Parent Item Name: AS350/AS355 Quick Release Basket/Long Cargo Tube Mounting Provisions, Fits LH/RH

DART SERVICE INSTRUCTION

TO AMEND INSTALLATION INSTRUCTIONS D350-607-3 Rev.D,
INSTALLATION INSTRUCTIONS D350-607-4 Rev. C AND
INSTRUCTIONS FOR CONTINUED AIRWORTHINESS ICA-D350-607 REV. 6

A	NEW ISSUE	AJS	14.05.16
REV.	DESCRIPTION	BY	DATE
DESIGN	AJS	DART AEROSPACE LTD HAWKESBURY, ONTARIO, CANADA	
DRAWN	AJS		
CHECKED		DRAWING NO.	REV. A
MFG. APPR.	N/A	DSI 9699	SHEET 1 OF 2
APPROVED		TITLE	SCALE
DE APPR.		LUG REPLACEMENT	NTS
DATE	14.05.16	COPYRIGHT © 2014 BY DART AEROSPACE LTD THIS DOCUMENT IS PRIVATE AND CONFIDENTIAL AND IS SUPPLIED ON THE EXPRESS CONDITION THAT IT IS NOT TO BE USED FOR ANY PURPOSE OR COPIED OR COMMUNICATED TO ANY OTHER PERSON WITHOUT WRITTEN PERMISSION FROM DART AEROSPACE LTD.

FIGURE 1: INSTALLATION OF D4775-041 FWD STRUT

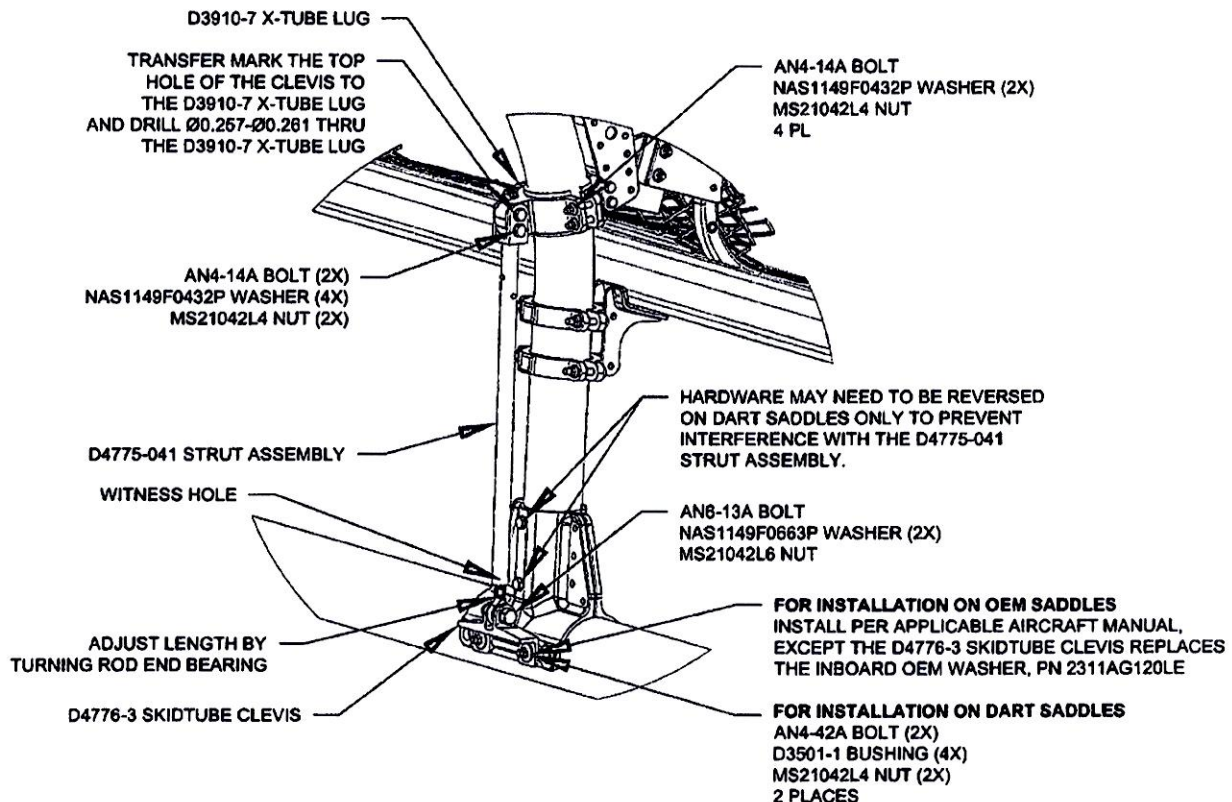
- 3.1 Substitute the Forward Lower D3910-5 X-Tube Lug with the D3910-7 X-Tube Lug as shown in Figure 1.
- 3.2 Install the forward D4775-041 Strut Assembly. Transfer mark from the upper hole on the clevis of the D4775-041 Strut Assembly to the D3910-7 X-tube Lug and drill thru the lug $\varnothing 0.257$ - $\varnothing 0.261$ as shown in Figure 1. Touch up chemical conversion coating per MIL-DTL-5541. Check the witness holes located at the bottom end of the D4775-041 Strut Assemblies to ensure that the thread from the rod end extends past the witness hole.
Torque MS21042L4/-4 nuts to 50-70 in-lbs (5.7-7.9 N-m). Torque MS21042L6/-6 nuts to 160-190 in-lbs (18.1-21.5 N-m).
- 3.3 Complete the installation in accordance with Installation Instructions D350-607-3 Rev. D or D350-607-4 Rev. C.
